**Subject: Deadline for Beginning Implementation of the Interim Remedial Action
Revised Cleanup and Abatement Order No. R9-2009-0124 dated
December 23, 2009
(CRWQCB-SDR Case #9UT1351, GeoTracker Site ID #T0605902379:bpulver)**

Subject: Olin Response to Central Coast Water Board Comments
SLIC: 425 Tennant Ave, Morgan Hill
Second and Third Quarter 2006 Groundwater Monitoring Reports,
and East of Site Characterization Report
MACTEC Project No. 6100070002-09.07

Re: Response to City of San Juan Capistrano (City) Letter Dated November 25, 2009
concerning the October 29, 2009 Technical Meeting

Capture Area of Proposed Deep Aquifer Extraction Well
 Tennant Well On
 Response to Central Coast Water Board Comments
 Olin/Standard Fusee Site
 Morgan Hill, California

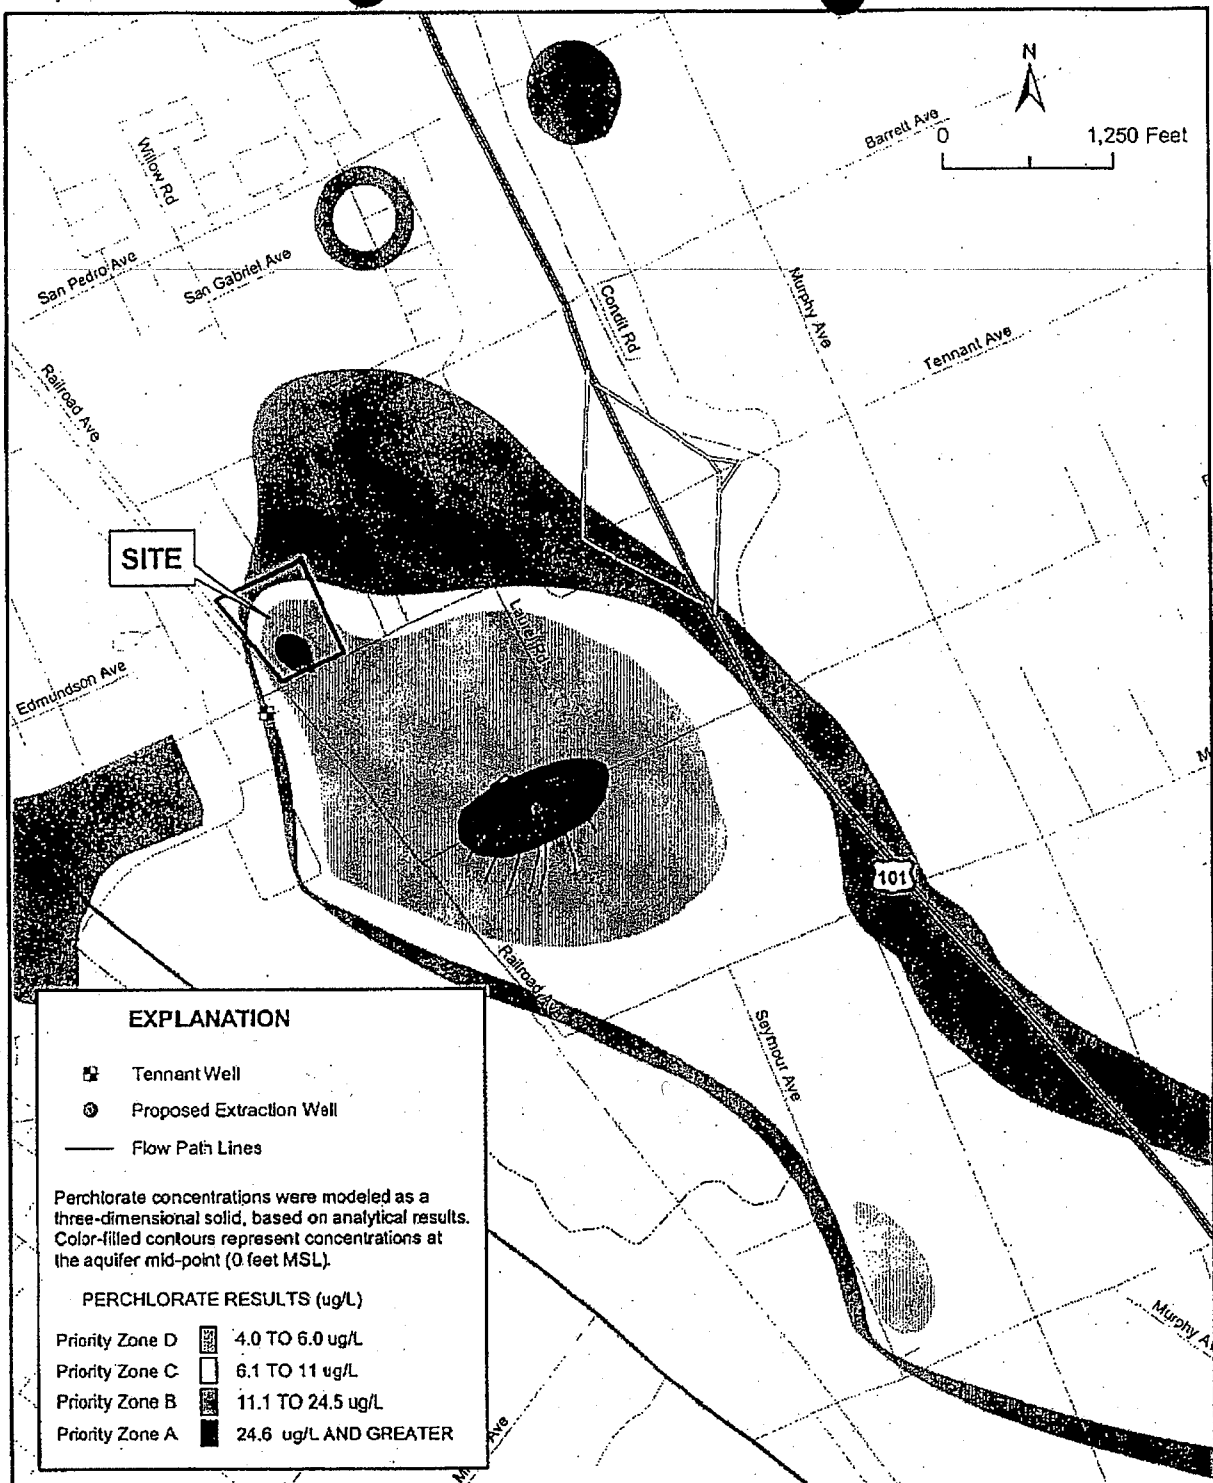
Comment 2. Provide an analysis of how the Tennant Well pumping affects perchlorate distribution and capture zones in the intermediate and deep aquifer zones. The analysis should evaluate if the Tennant Well is pulling the perchlorate plume downward, and to what extent the Tennant Well is providing hydraulic containment of the perchlorate plume in the intermediate and deep aquifer.

As reported in the *Area I Plume Migration Control Feasibility Study* (GeoSyntec, 2007), one extraction well is proposed for deep aquifer hydraulic containment of perchlorate within Assessment Area I. The numerical simulations referenced in this report include continuous operation of the Tennant Well. At the request of the Water Board, the deep aquifer capture simulation was modified to illustrate the potential capture area of the proposed extraction well without the influence of pumping from the Tennant Well. Potential capture areas from the proposed extraction well with respect to the Tennant Well operation as both on and off are illustrated on Figures 2 and 3. As these figures illustrate, that very little change occurs in the capture area of the proposed deep extraction well whether the Tennant Well is on or off.
